Re: Paric Corporation Project No. 15051
15051-Webster University Interdisciplinary Science Building
CP-055 - ASI#35 - A/V Revisions

Architect's Supplemental Instructions

Architect's ASI No: 035

Project:
Webster University
Interdisciplinary Science
Building

E0101.A

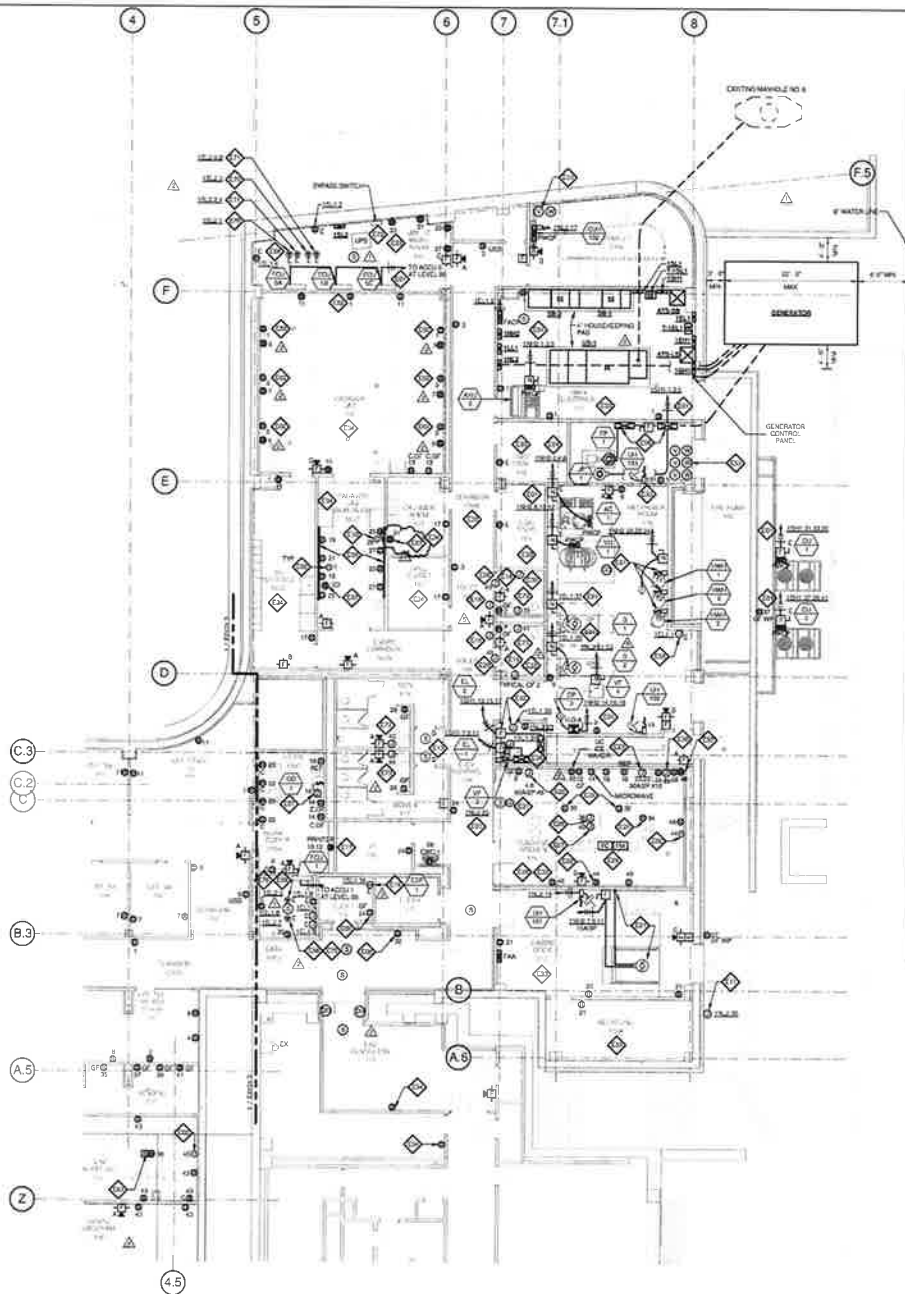
SHEET E0101.A LEVEL 01 AREA A FLOOR PLAN – ELECTRICAL

- Add quadruplex outlet and associated circuit in Cylinder Room 187 for AV rack.

E0102.A

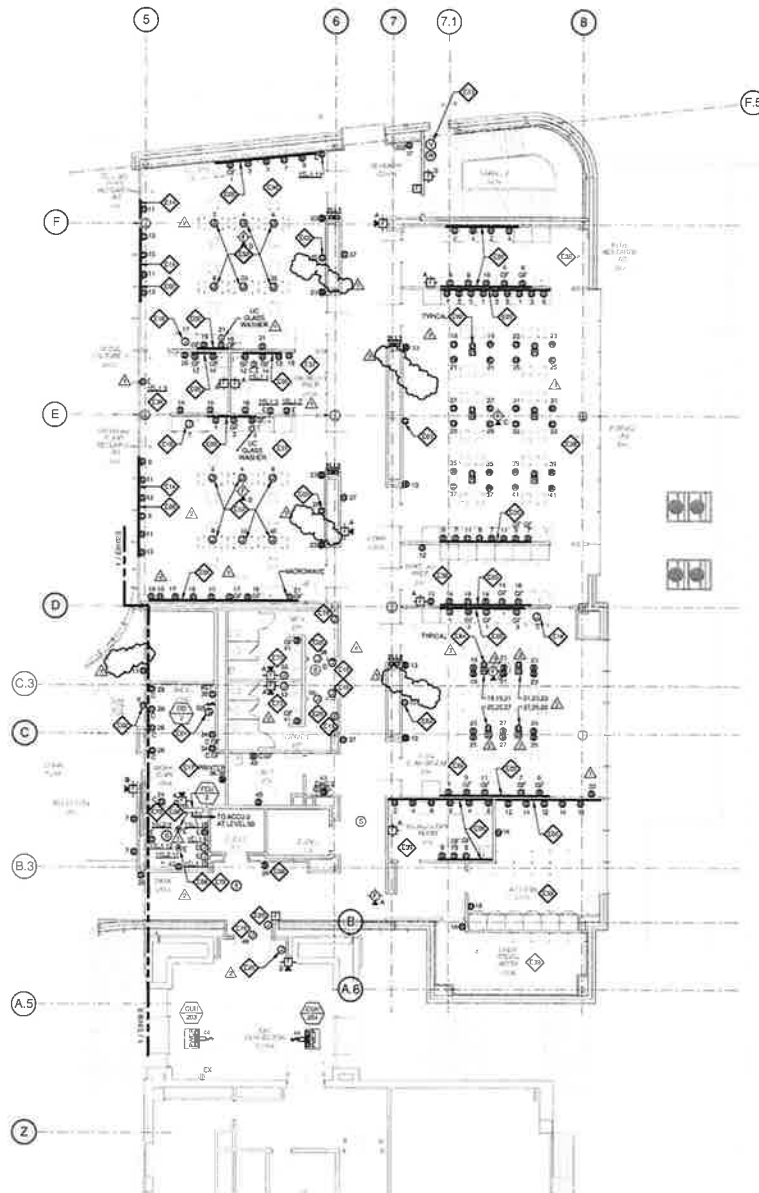
SHEET E0102.A LEVEL 02 AREA A FLOOR PLAN – ELECTRICAL

- Delete AV rack quadruplex receptacle and associated circuit in Classroom 276.
- Delete AV rack quadruplex receptacle and associated circuit in Lab 283.
- Delete AV rack quadruplex receptacle and associated circuit in Lab 284.
- Delete AV rack quadruplex receptacle and associated circuit in Lab 291.

LEVEL 01 FLOOR PLAN - AREA A

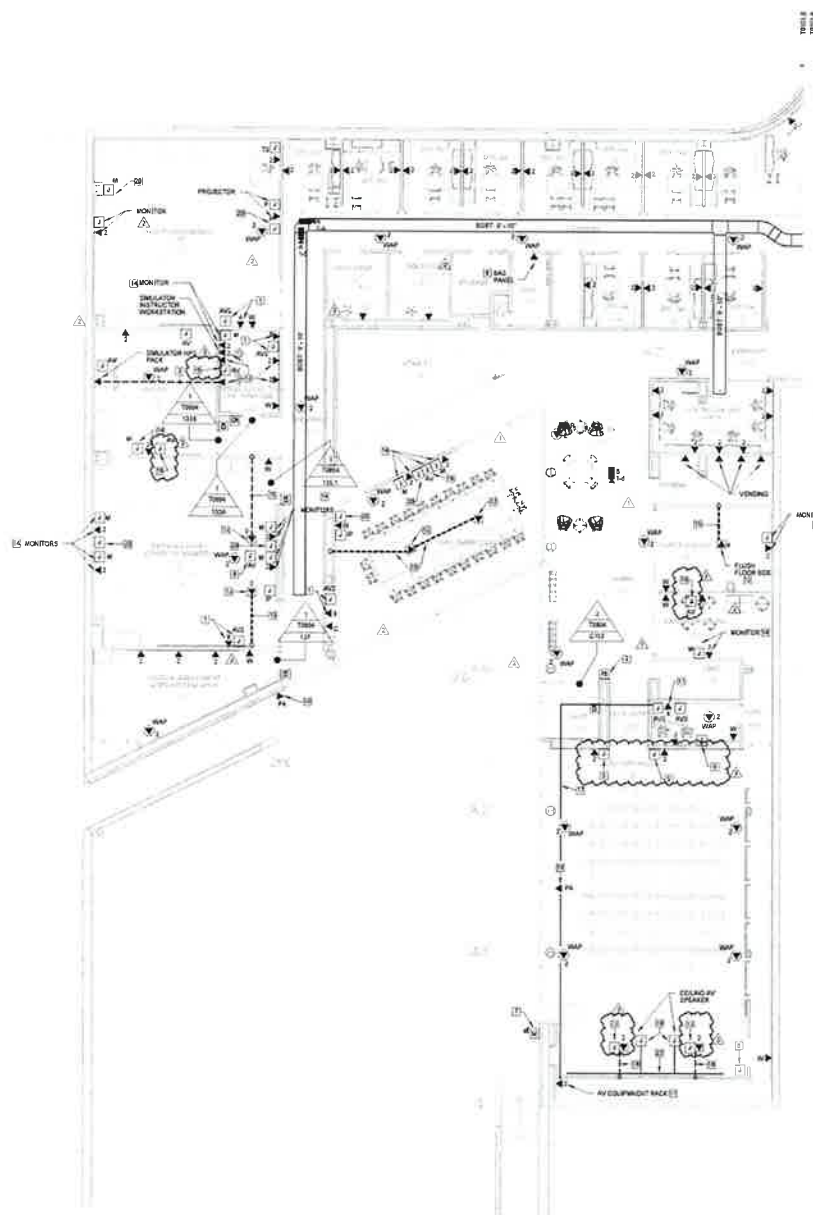
Drawing T0101.A dated 11/10/16

Furnish and install:

(12) Cat6A data cables

Deleted:

(1) Dual Cat6A data locations.

(1) Single A/V Cat6A in ceiling data location.

(6) Single A/V Cat6A in ceiling data locations.
